Docket No. 50-219

Change No. 1  
License No. DPR-16

SAFETY EVALUATION BY THE DIVISION OF REACTOR LICENSING

PROPOSED CHANGE NO. 1 TO TECHNICAL SPECIFICATIONS

**FIGURE TS-1 FUEL CLADDING INTEGRITY SAFETY LIMIT.**

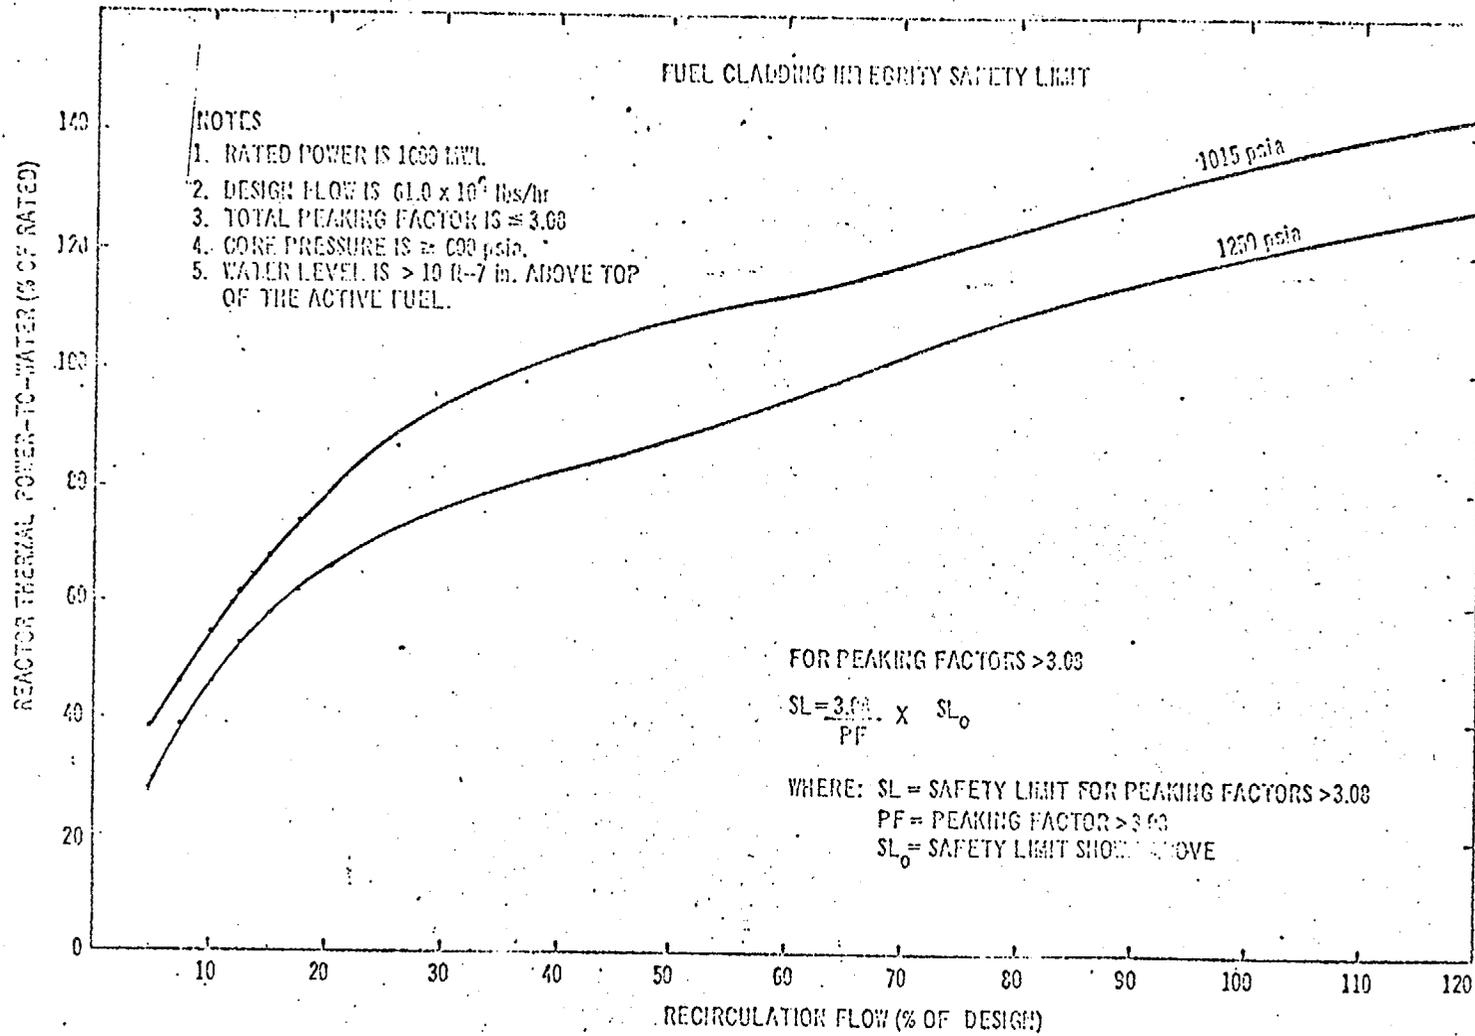
We have reviewed your Change Request No. 1 dated November 11, 1969, and Supplement No. 1 dated November 12, 1969, requesting a change to Figure 2.1.1 and Section 2.1.B of the Technical Specifications to Provisional Operating License No. DPR-16. The proposed change would extend the fuel cladding safety limit, based on a minimum critical heat flux ratio of 1.0, to include the region of operation between 5% core coolant flow and 20% core coolant flow.

Accordingly, Figure 2.1.1 is replaced by the attached Figure TS-1 and Section 2.1.B is changed to read:

Recent data taken at the Oyster Creek reactor indicate that natural circulation flow may be less than had been expected. As a result, during the transient following a five-pump trip, reactor flow may be as low as 15% when 21% power is achieved. The proposed safety limit, based on the critical heat flux correlation of APED-3892, establishes a limit which would permit operation with as little as 5% flow between 20% and 30% power. Below 5% flow, the safety limit would be established at 20% power.

"B. When the reactor pressure is less than 600 psia or reactor flow is less than 5 percent of design, the reactor thermal power shall not exceed 320 Mwt."

the safety analysis report (SAR). This correlation is more conservative in the low-flow region, 5% to 20% flow, than it is for greater flow. This basis provides sufficient justification for the establishment of the proposed safety limit.
